Access Compliance Report

Public Rights-of-Way

Intersection ID: 10025368	Main Street: E_8TH_ST	Cross Street: N BREVARD ST	Location: E
ADA ID: 17C2E9DBEA90	Ramp Type: BlendTrans1	Initial Pass/Fail: Pass	Overall Compliance: No
Severity Score: 15.25			
Codes/Mitigation Info/Possible Solution		Field Measurements/Component Compliance

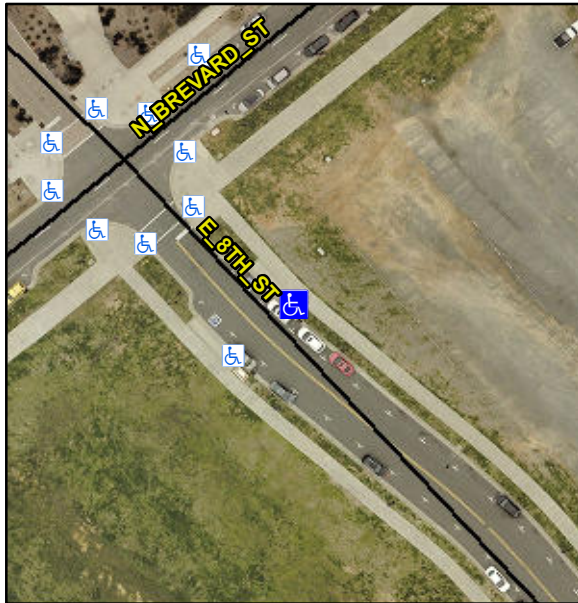
ACCESS AISLE RAMP

R304.5.3, R304.2.2-Perp, R304.3.2-Para, R304.2.3, R305, R304.5.4

Remove & Replace Curb Ramp With Two New Directional Ramps or Equivalent. Remove & Replace Gutter.
